SERVICE BULLETIN

TS-940S PLL UNLOCK

4-8-86

Change C168 from 33 pF to 15 pF

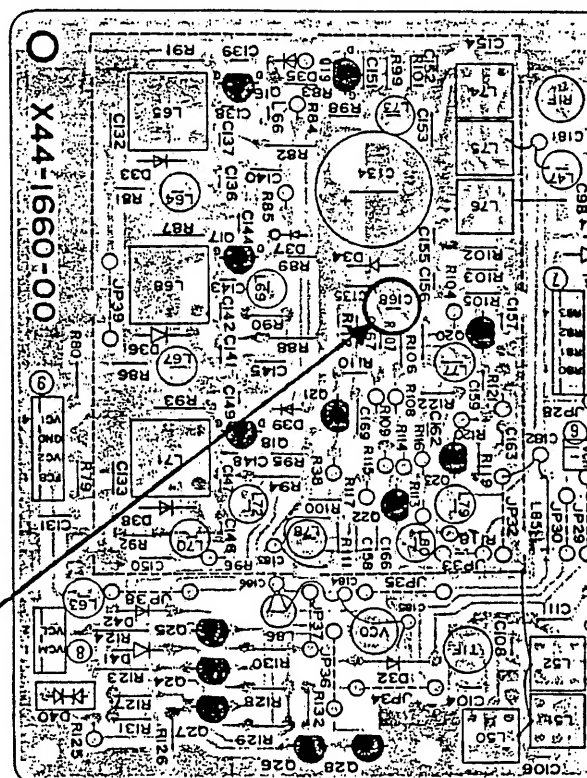
Reports of a PLL Unlock on the lower frequencies may be due to low VCO levels. The following change will increase the VCO level and should prevent reoccurrence of this symptom.

1. On the RF Unit (X44-1660-00) change C168 from a 33 pF capacitor to a 15 pF 50 v capacitor.
2. Readjust the VCO BPF (RF unit L74-76) according to the instructions contained in the TS-940S service manual.

C168.....change to 15 pF 50 v (CC45SL1H150J)
